SPYDER 2024 No Reverse When Hot - 142594

Reverse gear not engaging when the unit is hot

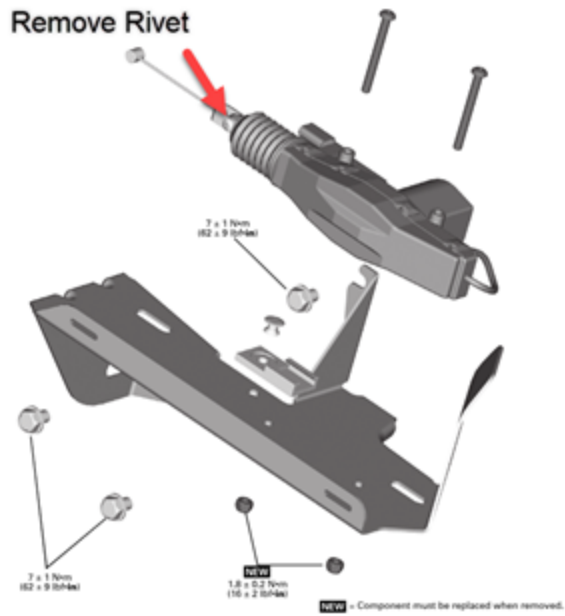
On some MY24 the Reverse Gear fails to engage when the unit is hot. Our tests confirms that some reverse actuators failed because of the internal thermal protection is too sensitive.

Actuator 710011269 was developed to cure this symptom

The actuator will need to be installed on the existing bracket along with the cable

1x 710011269 ACTUATOR_REVERSE
